STAFF RECOMMENDATION

NCPC File No. 6562

ANACOSTIA WATERFRONT TRANSPORTATION ARCHITECTURE DESIGN STANDARDS

Submitted by the District Department of Transportation

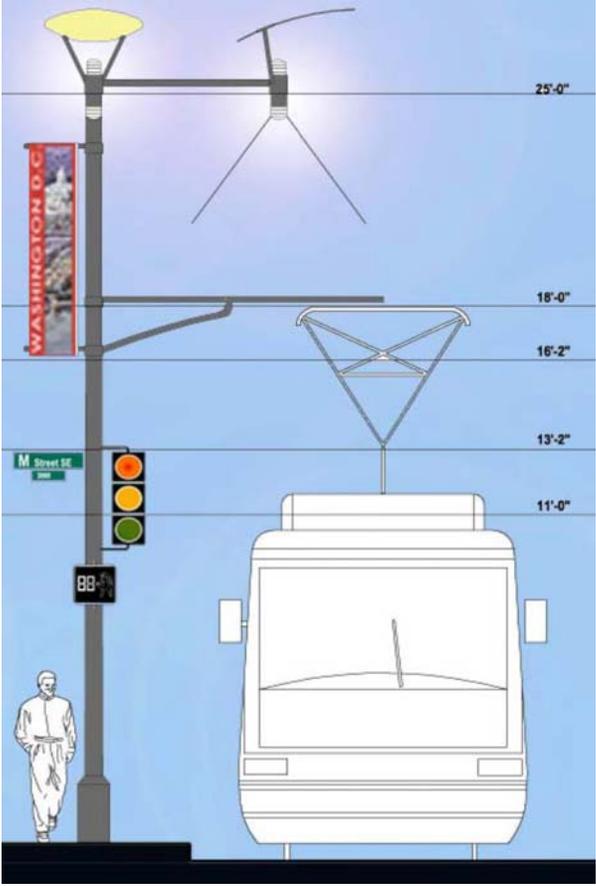
While staff supports DDOT's effort to utilize contemporary lighting, staff believes that the contemporary lighting standards shown in the manual will become dated in their design. Staff is also concerned about how contemporary lighting on South Capitol Street would transition onto the Fredrick Douglass Bridge, which has yet to be designed. To ensure lighting that is contemporary but still appropriate for the Washington DC context, staff recommends that DDOT explore alternative contemporary light fixtures that feature an illuminated globe on a post, which would be more compatible with the traditional Washington Globe fixture.

- For corridors that cross the AWI boundary, DDOT develop streetscape designs that are continuous on both sides of the boundary to create visual continuity between the city and the waterfront, or transition the streetscape elements at logical points along the corridors such as at circles, squares or parks.
- DDOT explore alternative contemporary lighting fixtures for Symbolic Corridors that are more compatible with the traditional Washington Globe fixtures.

London Pavers

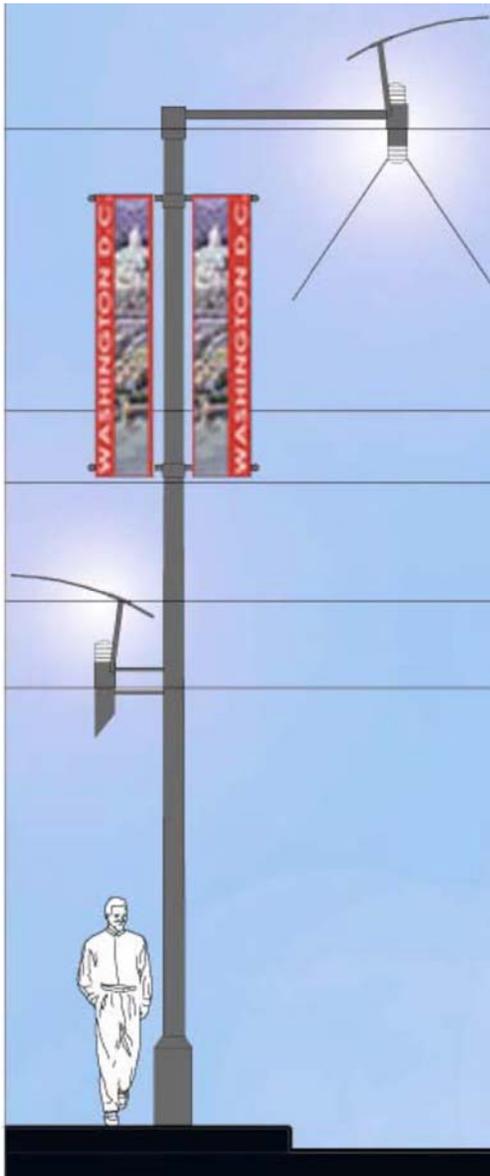
In the Monumental Core, aggregate sidewalks are generally limited to areas adjacent to significant green spaces such as the grounds of the U.S. Capitol and the National Mall, or within specific contextual areas such as Federal Triangle. Concrete London pavers are commonly used in more urban areas. Staff prefers the London pavers as more characteristic of Washington, but believes that selecting a specific material is premature as the character of the Symbolic

Corridors, particularly South Capitol Street, has not yet been defined. Therefore, staff supports the selection of a uniform treatment for these Symbolic Corridors, but recommends that the selection of a specific paving material occur later in the project planning process, as the character of the overall streetscape becomes more defined and following further study of alternatives.

- DDOT work with Washington Metropolitan Area Transit Authority to develop guidelines for bus shelters within the AWI area that are compatible with the planned surrounding streetscape.
- DDOT utilize uniform paving materials along Symbolic Corridors, but select specific materials later in the project planning process, during the streetscape design development phase.
